Re: RESPONSE TO COMMENTS ON THE CONSOLIDATED RESPONSE TO  
COMMENTS ON THE RI/FS/PRAP FOR SITE 09 ALLEN HARBOR LANDFILL, NAVAL  
CONSTRUCTION BATTALION CENTER (NCBC) DAVISVILLE, RI

# 1. INTRODUCTION

## 2. RESPONSE TO COMMENTS

# STABILITY ANALYSIS WITH 1V ON 3H SLOPE

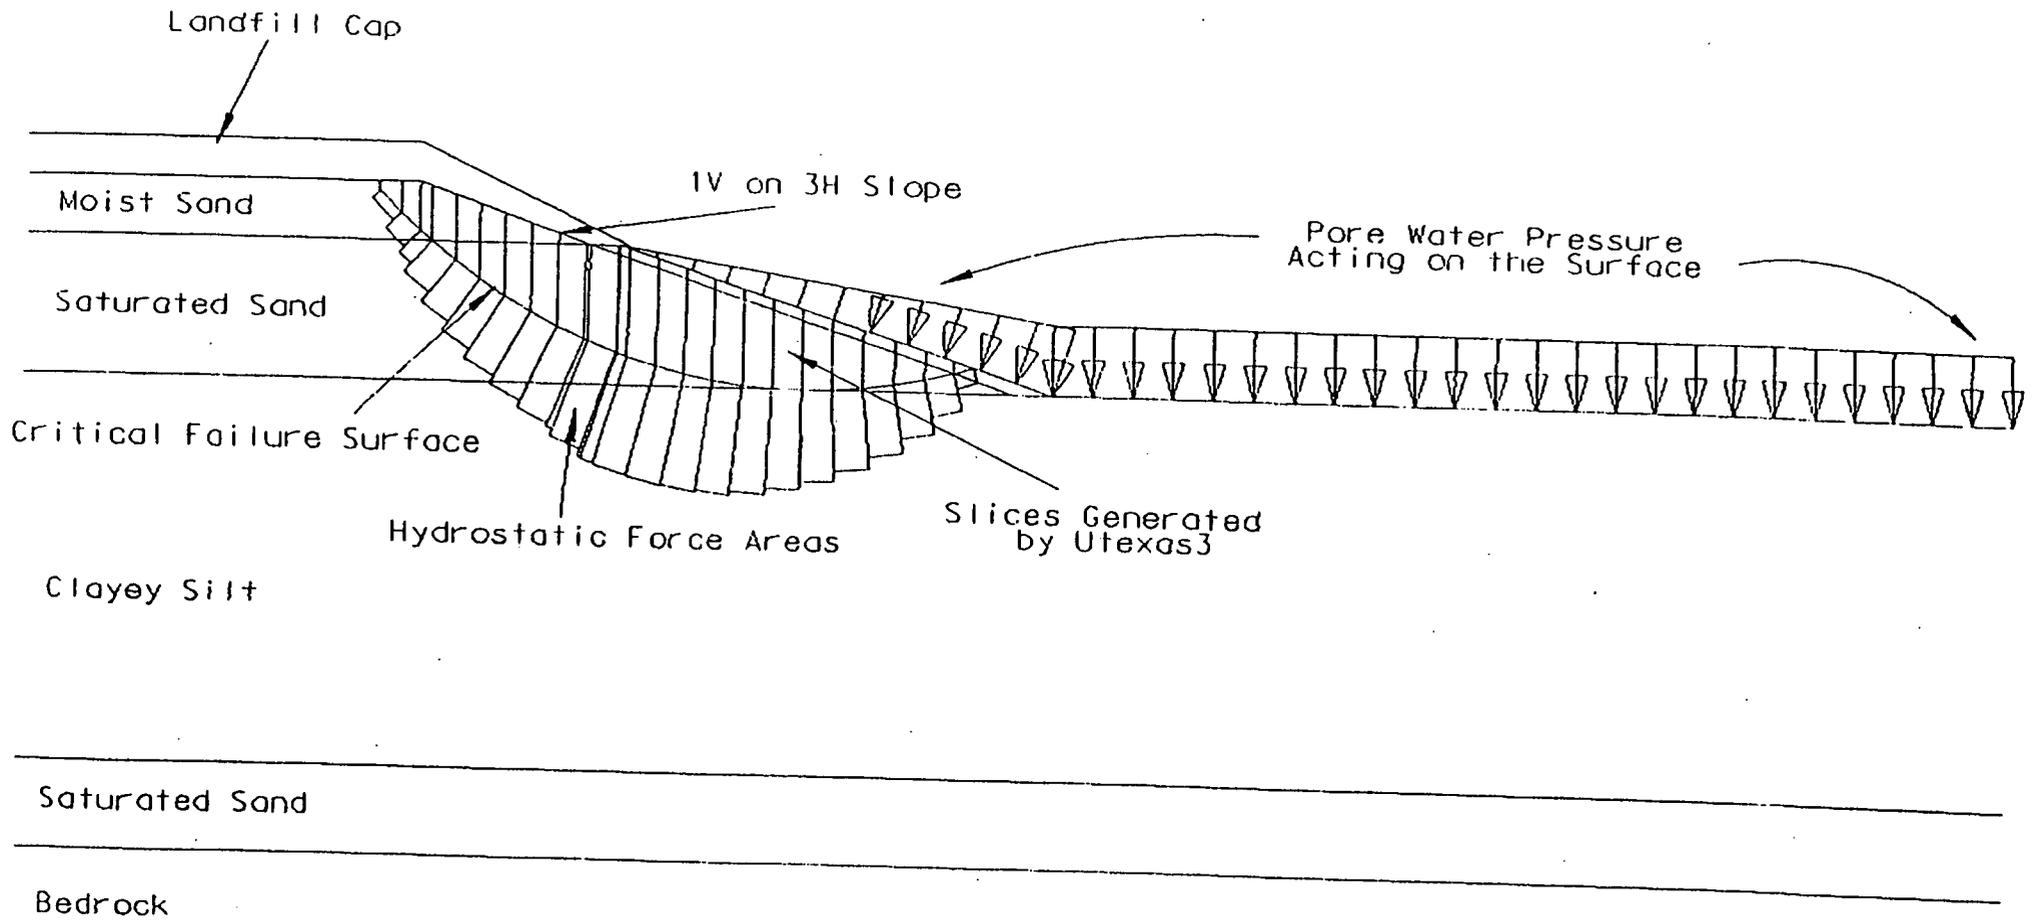
**Response to Comment 32: (Attachment C, p. 3, Section 3.b)**

For the normal tidal condition (5 ft. wave height), the slope was assumed to be regraded to 1V on 3H. Furthermore, to increase the stability of the slope as well as to decrease the chance of a "quick condition" occurring, it was assumed that a 3 ft. thick layer of riprap was placed on the slope. The resulting Factor of Safety was found to be 1.30. The Corps of Engineers normally assumes a Factor of Safety of 1.25 to be adequate for conditions similar to this. Based on this, a satisfactory

Factor of Safety was found. The attached Figure shows the assumed slope configuration as well as the results of the modeling effort.
